# Access Compliance Report

## Public Rights-of-Way

Intersection ID: 23847	Main Street: ARLANDES_DR	Cross Street: ROZIER_DR	Location: SE
ADA ID: EEA2776E5302	Ramp Type: PerpDiag	Initial Pass/Fail: Fail	Overall Compliance: No
Codes/Mitigation Info/Possible Solution		Field Measurements/Component Compliance	
Severity Score: 31.25

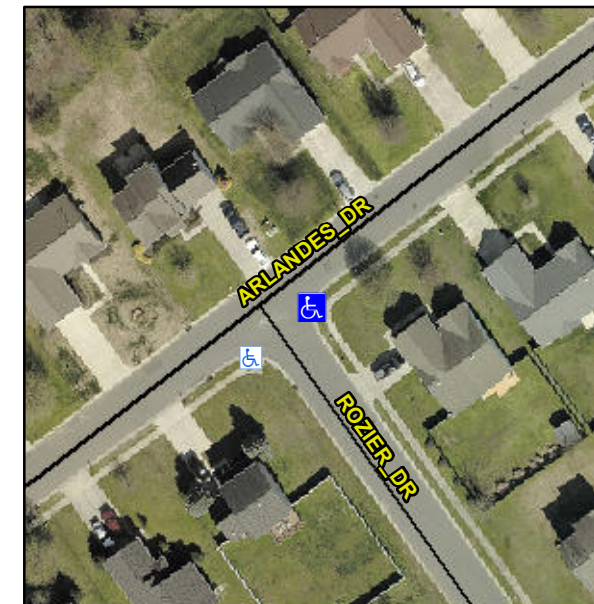
**Not Found, R304.5.1, R304.2.2, R304.5.3**

Compliance	Description	Data	Compliance	Description	Data
N/A	Ramp Length (in)	47.5	No	Ramp Slope (%)	8.4
No	Ramp Width (in)	35.5	No	Ramp XSlope (%)	2.3
N/A	Flare Type LT	N/A	N/A	Flare Type RT	N/A
N/A	Flare Slope LT (%)	N/A	N/A	Flare Slope RT (%)	N/A
N/A	Flare Traversable LT?	N/A	N/A	Flare Traversable RT?	N/A
N/A	Landing Length (in)	N/A	N/A	DWS Provided?	N/A
N/A	Landing Width (in)	N/A	N/A	DWS Contrast?	N/A
N/A	Landing Slope (%)	N/A	N/A	DWS Length (in)	N/A
N/A	Landing X Slope (%)	N/A	N/A	DWS Full Width?	N/A
N/A	Landing Curb? (Y/N)	N/A	N/A	DWS Offset (in)	N/A
N/A	Shared Landing?	N/A			
N/A	Gutter Ponding?	N/A	N/A	Gutter Slope (%)	N/A
N/A	Gutter Lip Ht (in)	N/A	N/A	Gutter X Slope (%)	N/A
N/A	Painted X Walk1?	No	N/A	Painted X Walk2?	No
	X Walk 1 Direction	To NW		X Walk 2 Direction	To SW
N/A	X Walk 1 Width (in)	N/A	N/A	X Walk 2 Width (in)	N/A
	X Walk 1 Slope (%)	0.0		X Walk 2 Slope (%)	1.0
	X Walk 1 X Slope (%)	0.3		X Walk 2 X Slope (%)	1.7

**Remove & Replace Curb Ramp With Two New Directional Ramps or Equivalent.**
